NOTICE OF ACCEPTANCE (NOA)

DESCRIPTION: Model 1675WDVM Aluminum Louver – L.M.I.

APPROVAL DOCUMENT: Drawing No. 1675WDVM, titled "1675WDVM Louver", sheets 1 through 12 of 12, prepared by Rice Engineering, dated 09/11/2018, with revision C dated 05/21/2024, signed and sealed by Wayne K. Helmila, P.E., bearing the Miami-Dade County Product Control revision stamp with the Notice of Acceptance number and expiration date by the Miami-Dade County Product Control Section.

NOA No. 24-0516.07
Expiration Date: August 30, 2028
Approval Date: July 18, 2024
Page 1

SA SAFE-AIR
N ILLINOIS, LLC.
1855 SOUTH 54TH AVE. CICERO, IL 60804
Tel. 708-652-9100 Fax 708-652-9100
TITLE: 1675WDM LOUVER
SKINNY WALL APPLICATION
HEAD AND SILL DETAIL

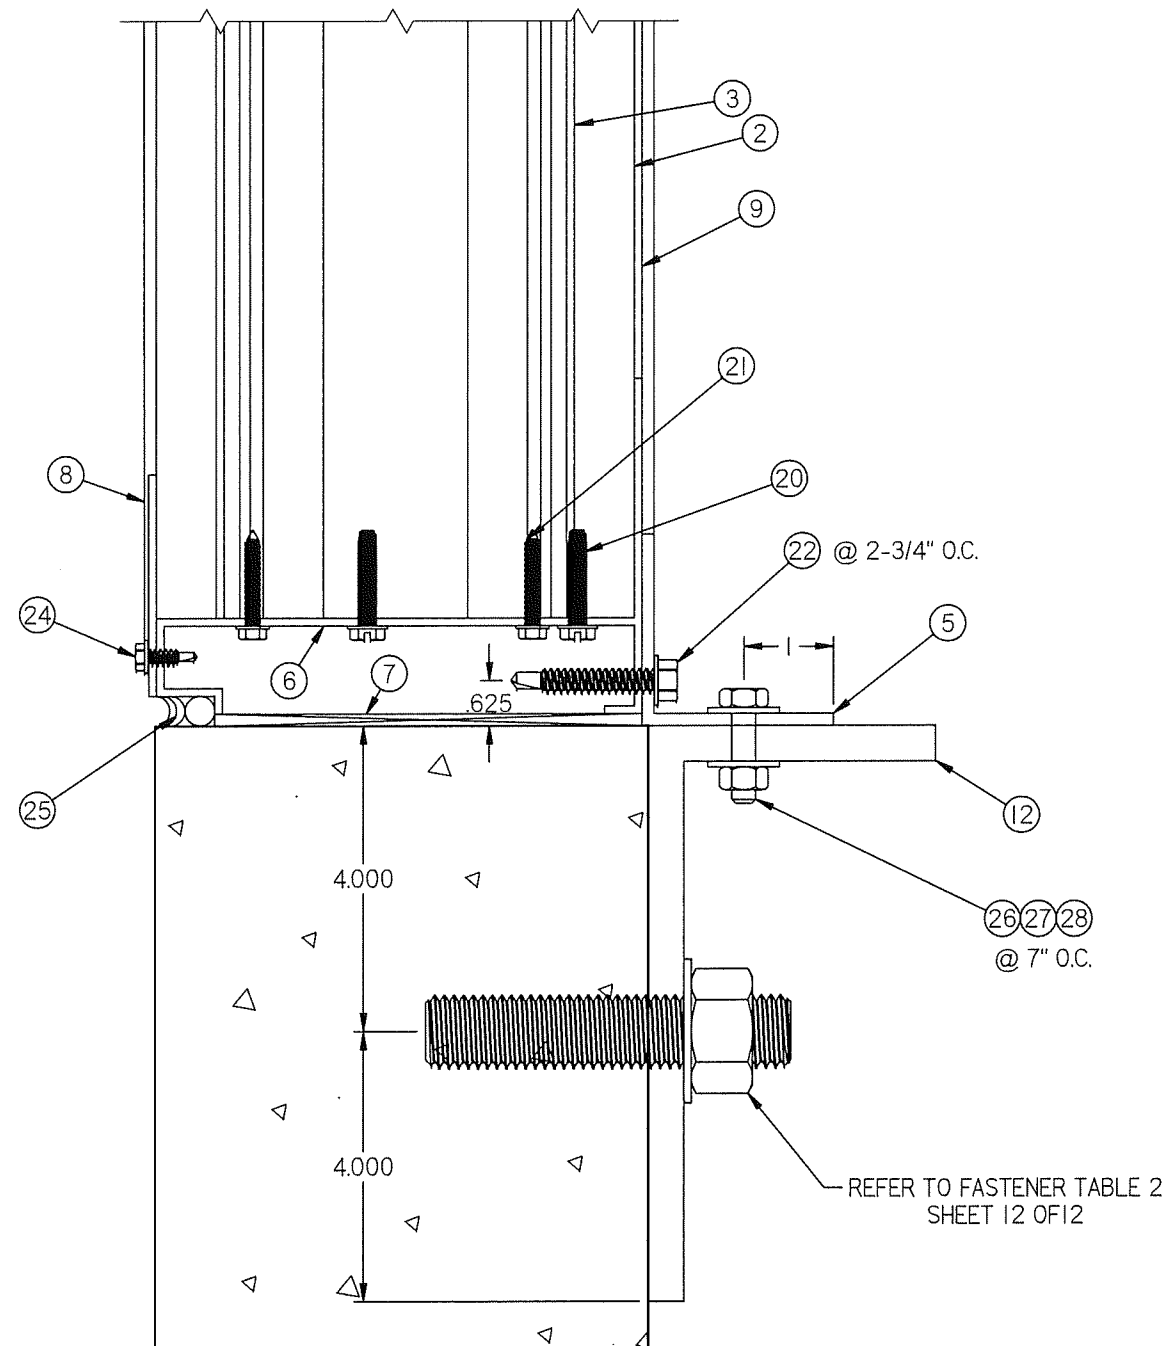
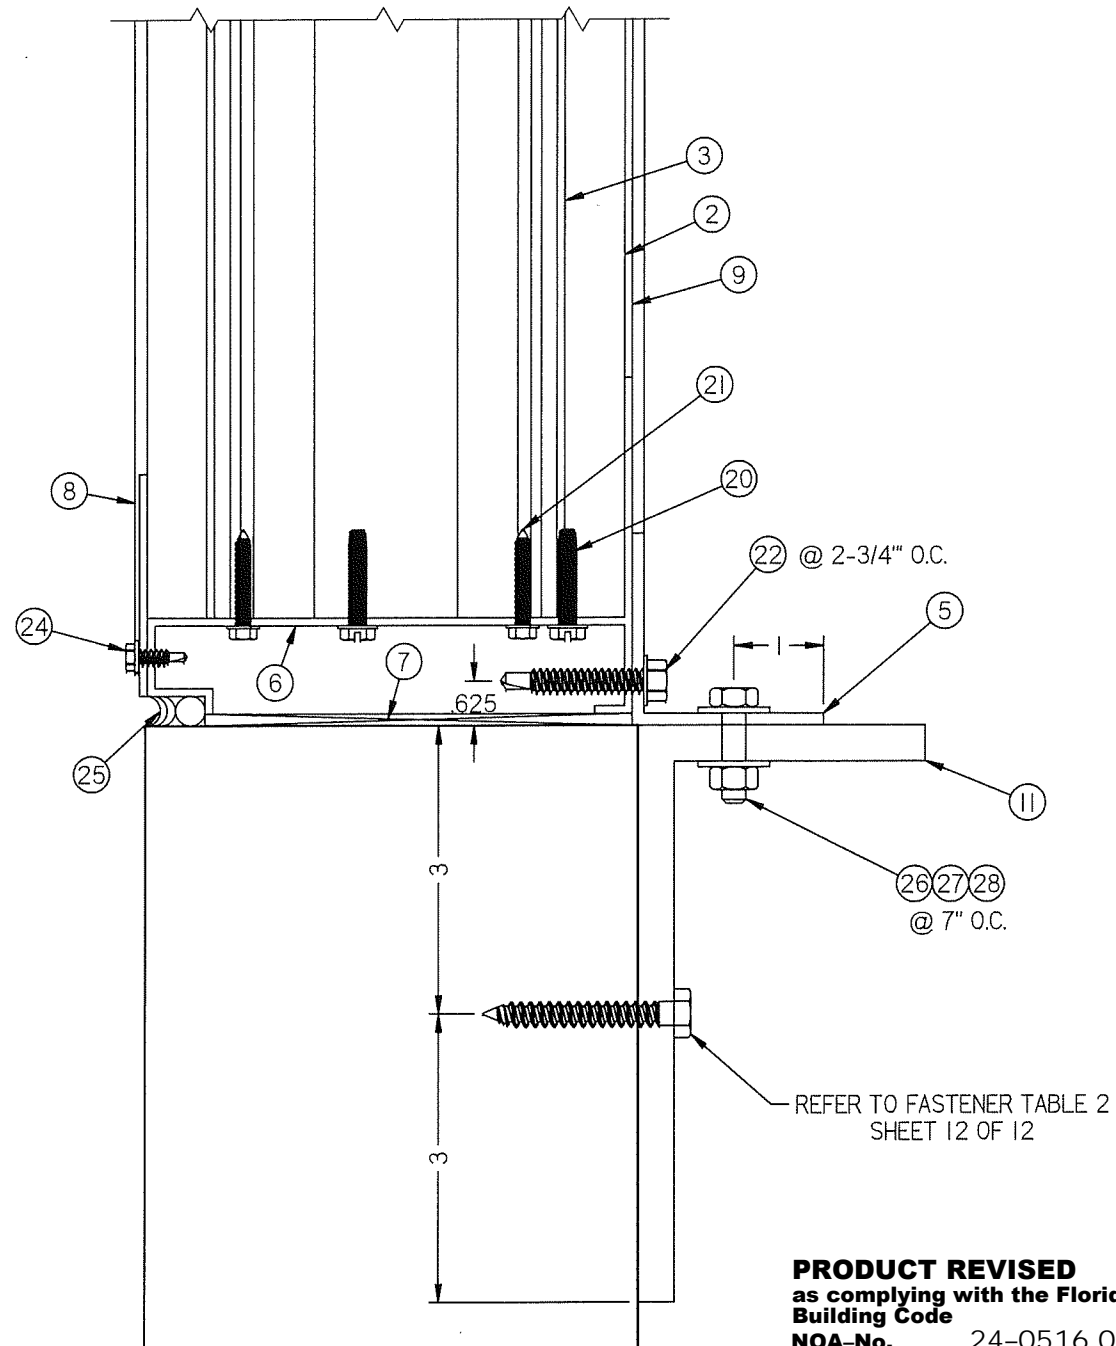
REV. C - UPDATED FASTENER NOTE TO
REFLECT CHANGES TO FASTENER TABLES
- CMU DETAIL UPDATED PER CALCULATIONS.

SA SAFE-AIR
NI ILLINOIS, LLC.
1855 SOUTH 54TH AVE. CICERO, IL 60804
Tel. 708-652-9100 Fax 708-652-9100
TITLE: 1675WDVM LOUVER
SKINNY WALL APPLICATION
HEAD AND SILL DETAIL
CONT.

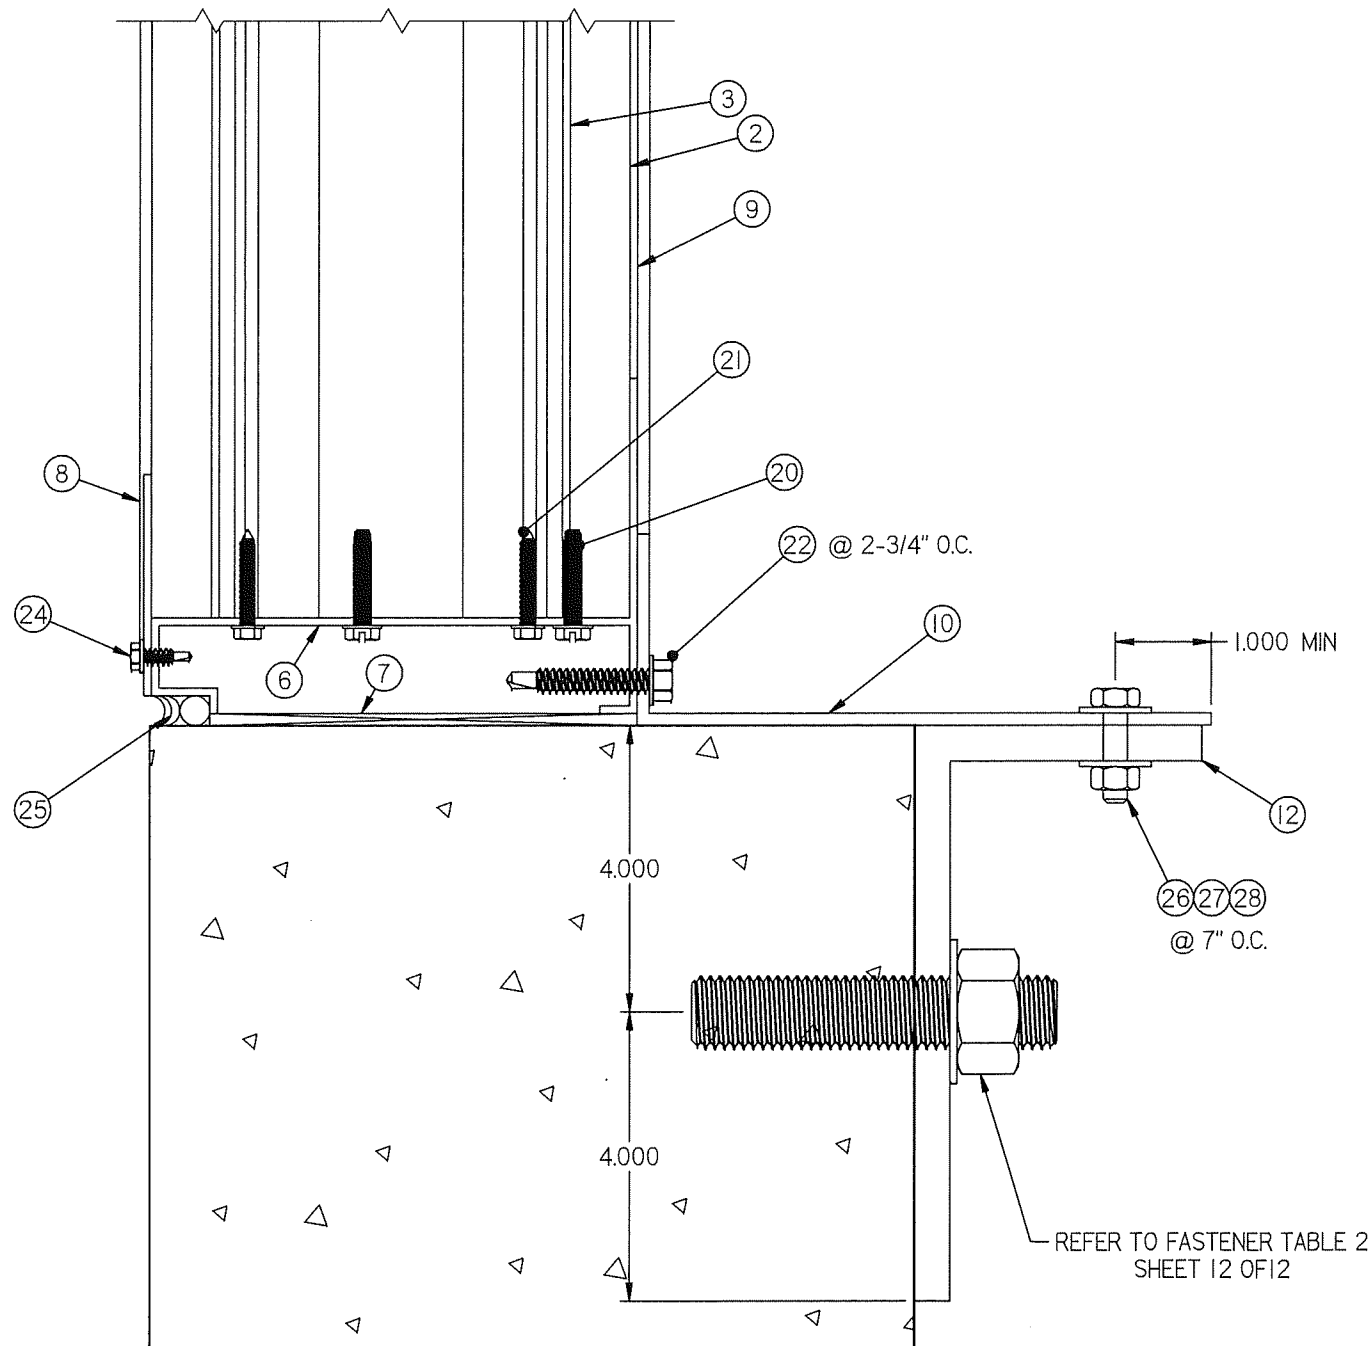
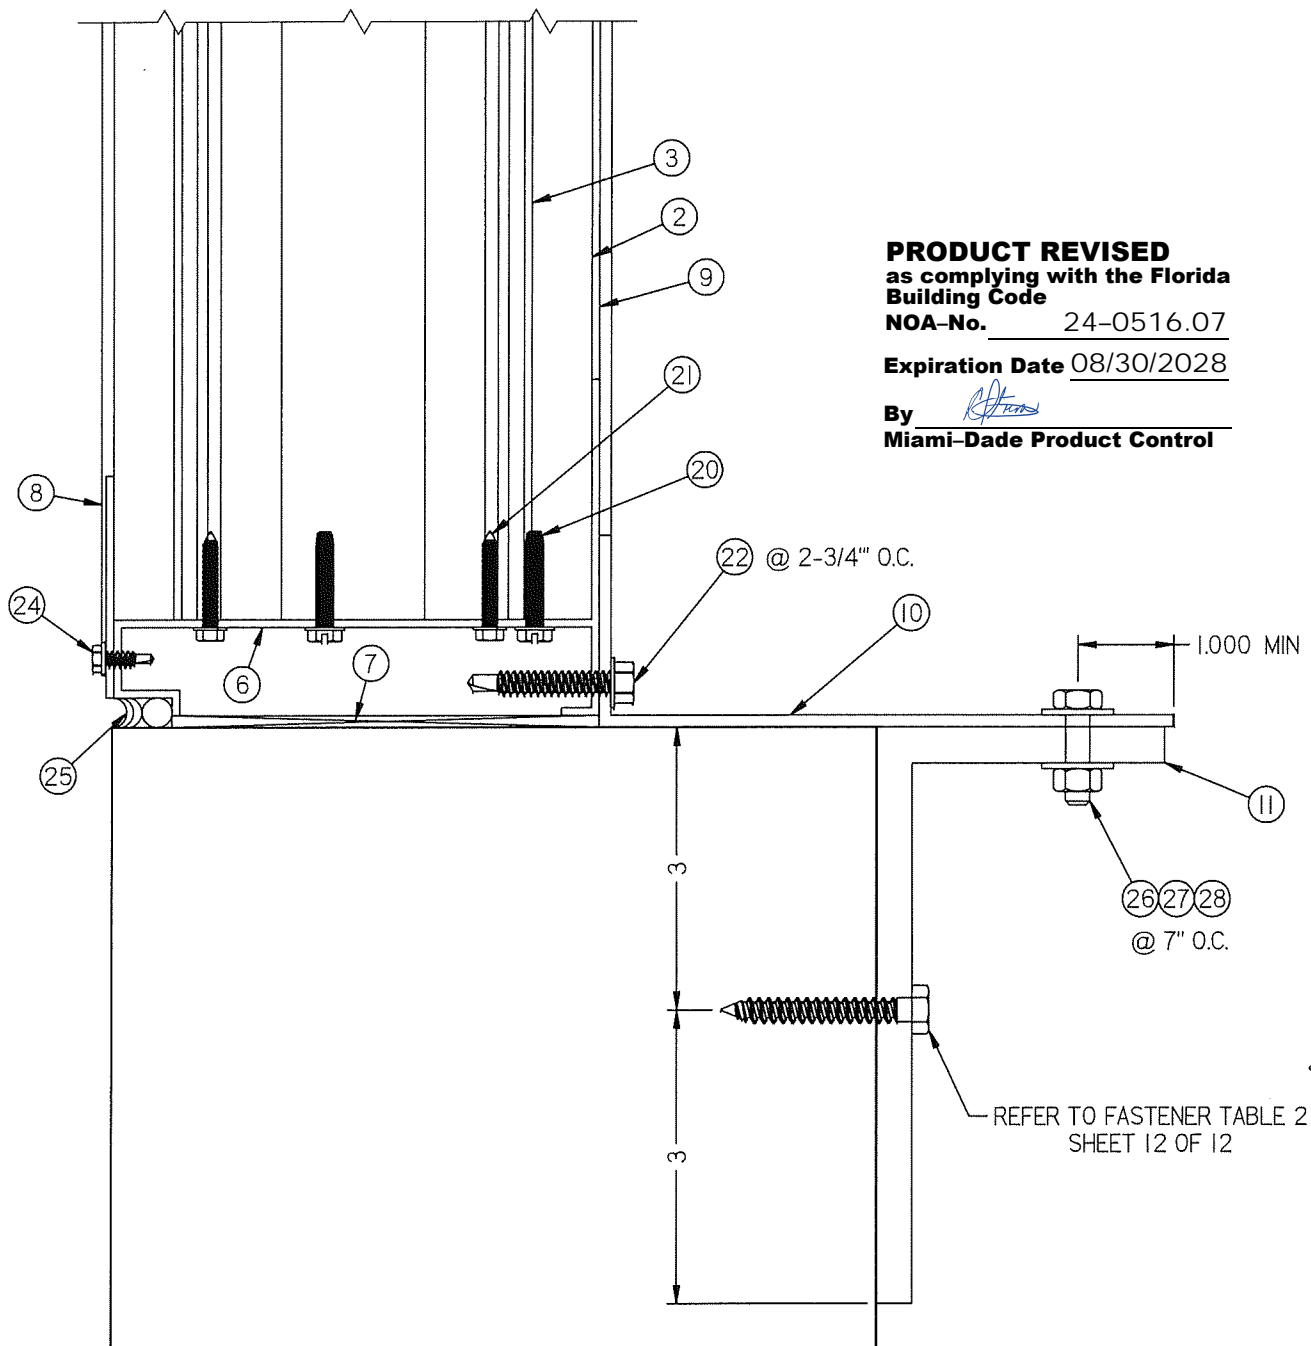
REV. C - ADDED PAGE TO SHOW ALTERNATE
INSTALLATION FOR THICKER SUBSTRATES.

SA SAFE-AIR
 NI ILLINOIS, LLC.
 1855 SOUTH 54TH AVE. CICERO, IL 60804
 Tel. 708-652-9100 Fax 708-652-9100
 TITLE: 1675WDVM LOUVER
 BLADE STRAP DETAIL

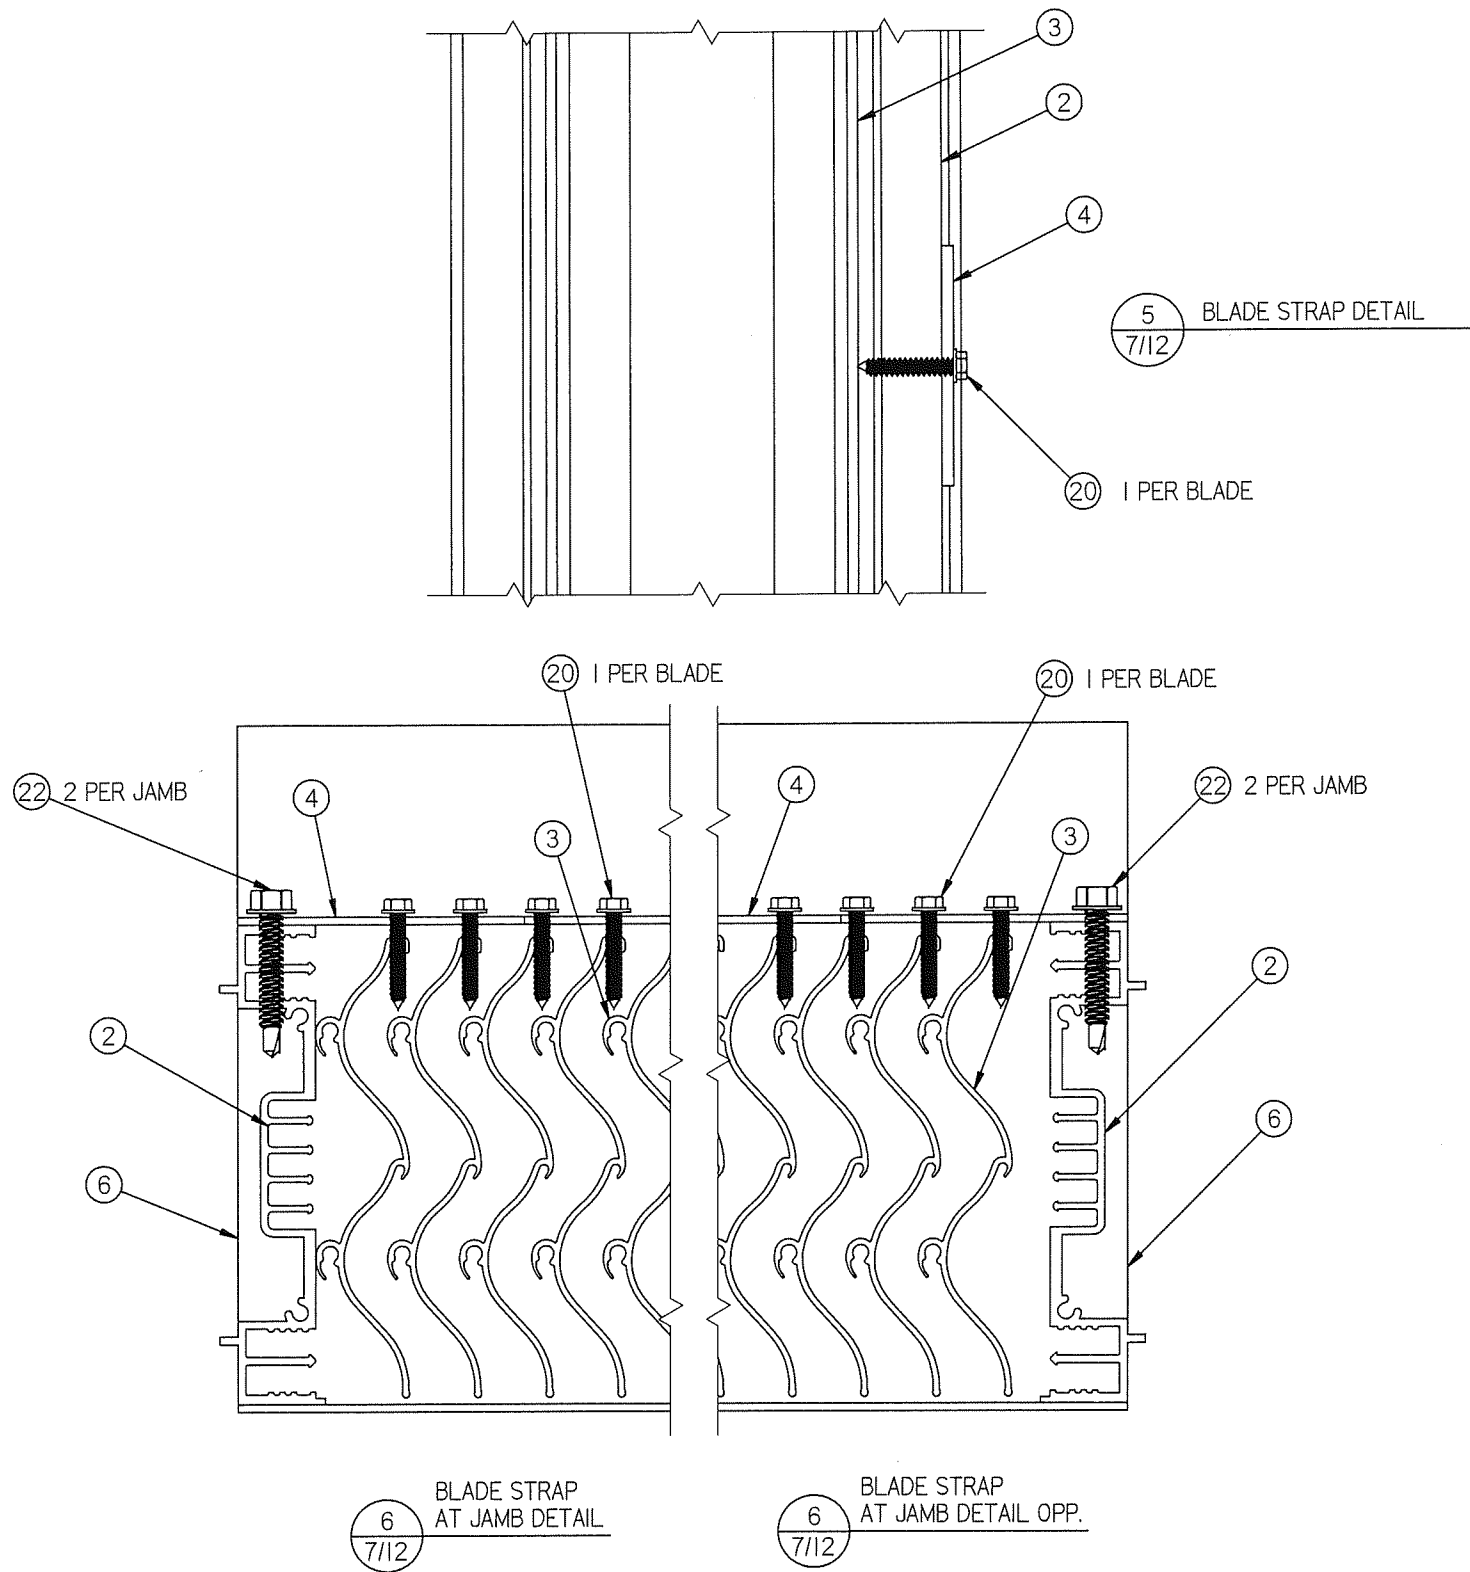
REV C: ADDED NOTE FOR ANGLE
INSTALLATION O.C.
- UPDATED PAGE NUMBER

SA SAFE-AIR
NI ILLINOIS, LLC.
1855 SOUTH 54TH AVE. CICERO, IL 60804
Tel. 708-652-9100 Fax 708-652-9100
TITLE: 1675WDVM LOUVER
PART PROFILES

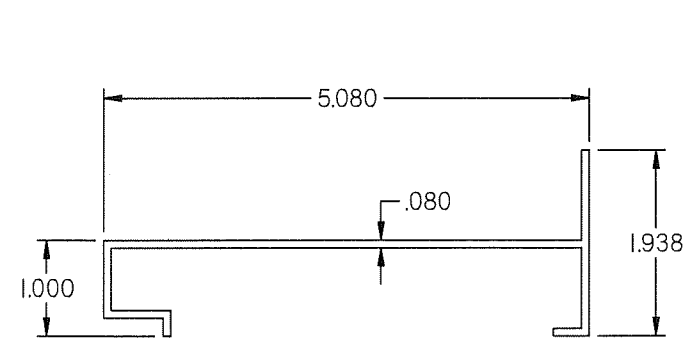
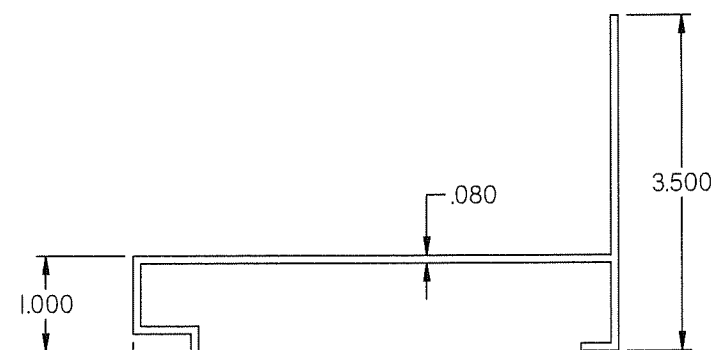
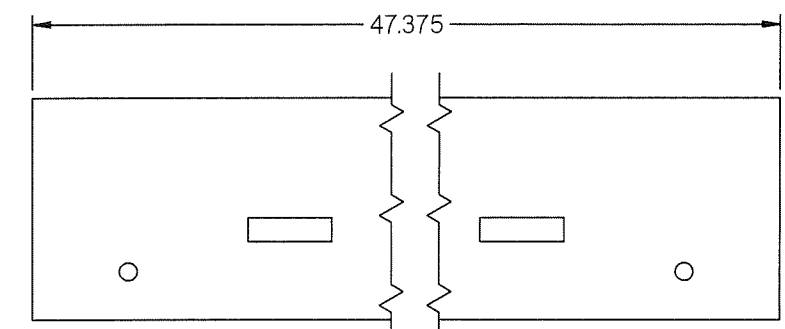
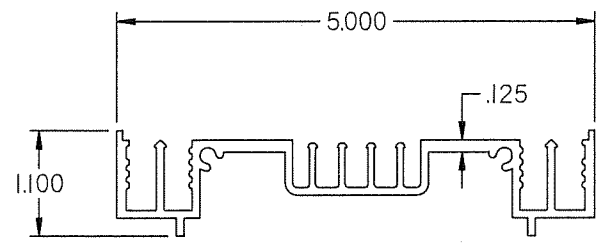
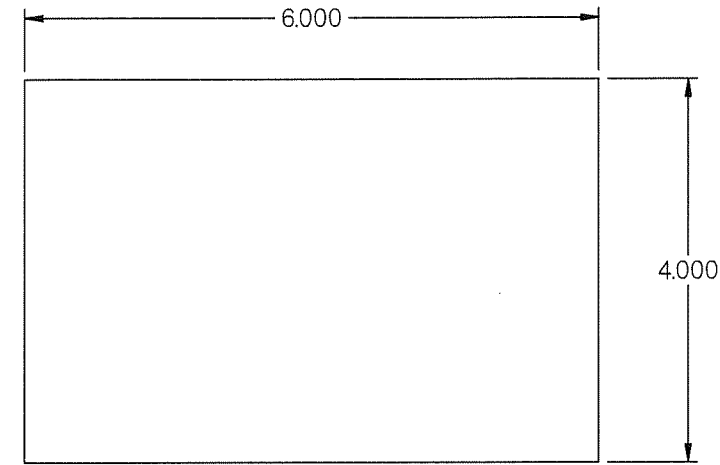
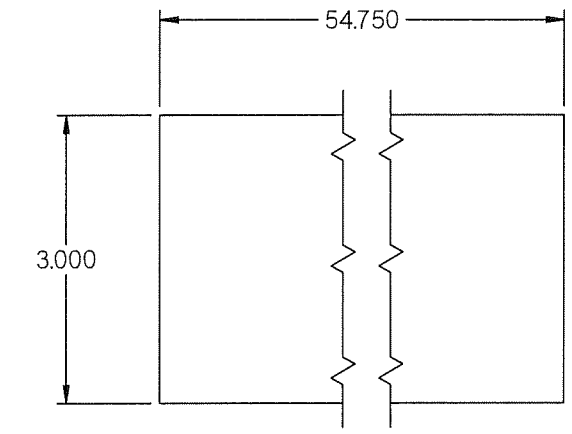
REV. C - UPDATED PAGE NUMBER
- UPDATED SILL, JAMB
- ADDED BAFFLE, 3 X 8 X 3/8 ANGLE
- ADDED 6 X 3 X 1/4 ANGLE
- ADDED JAMB STOPS
